## Addendum Submission

For the part retrospective retention of completed lakes Bridges and Puma, the retention and completion of part completed raised reservoirs Lakes 1, 2 and 3 (all for angling purposes) along with the clubhouse and detailed landscaping scheme at  
Monk Lakes, Staplehurst Road, Marden, Maidstone, TN12 9BS

0183/01  
Addendum Submission – Monk Lakes

1:500	27/09/19	RL	CW
JECT NUMBER:	DRAWING NUMBER:	REVISION:	
0183-04	0183-04/04	A

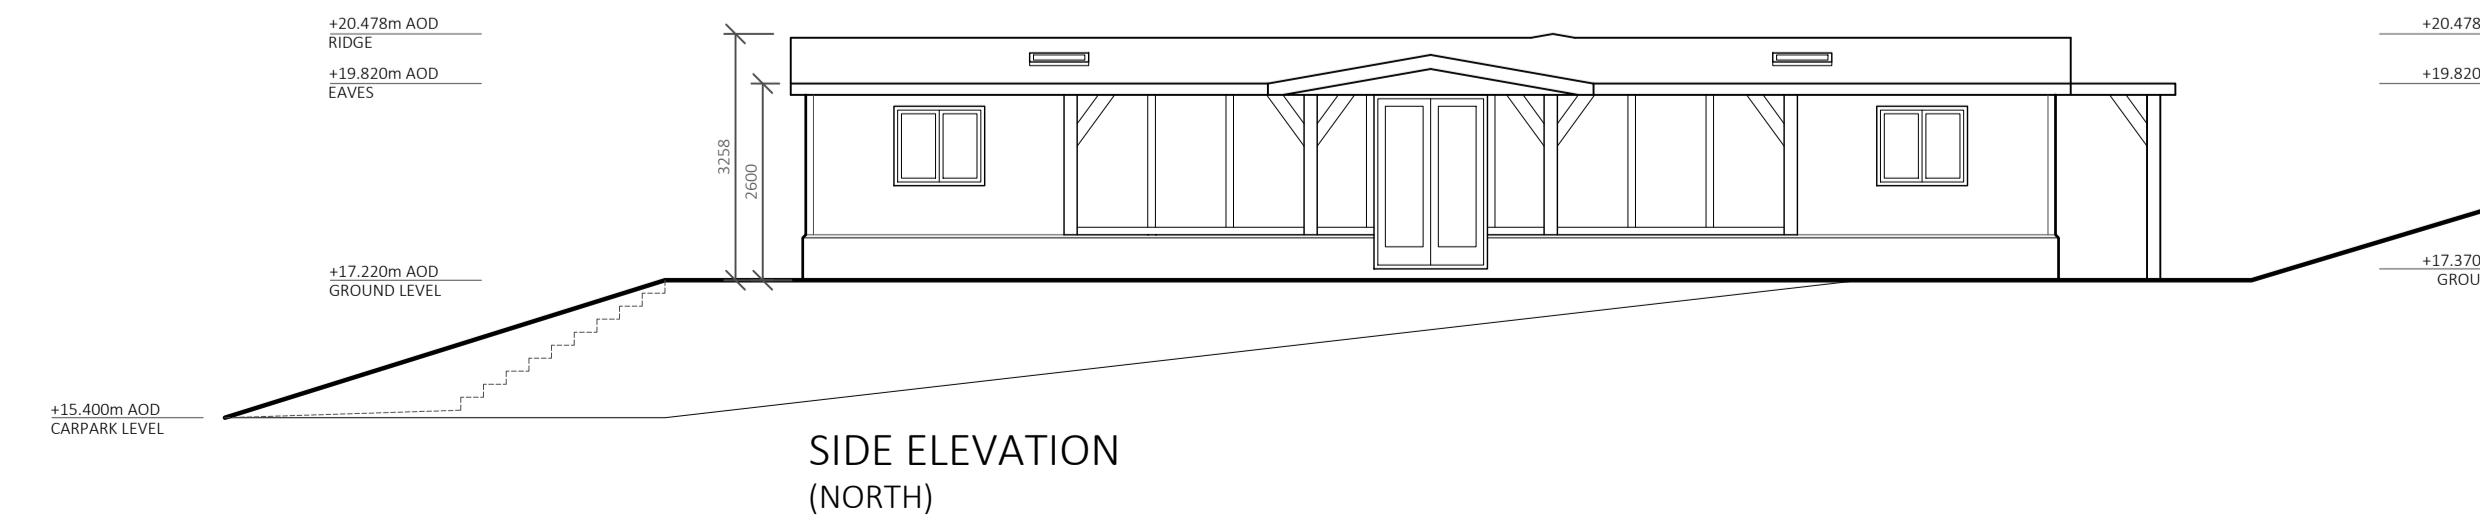
1.5 As part of the works undertaken to satisfy the Environment Agency and remove the holding objection, it has been agreed to raise the land surrounding the clubhouse building by nearly two metres for flood risk mitigation; the increase in land levels have been accounted for in the accompanying clubhouse carpark layout plan together with updated floor plans and elevations in relation to the clubhouse building itself. Given the increase in land levels it was considered reasonable and appropriate to reduce the ridge height associated with the clubhouse building floor plans and elevations so as to mitigate for any landscape impact created by an increase in the height afforded to the massing of the clubhouse itself on the wider area. It is considered that the mitigation proposed in the significant reduction of the ridge height of the clubhouse building has sufficiently addressed any issues in this regard.

CLUBHOUSE POSITION AND ORIENTATION, CARPARK LEVELS AMENDED	RL	04/10/19
	DESCRIPTION:	BY:	DATE:
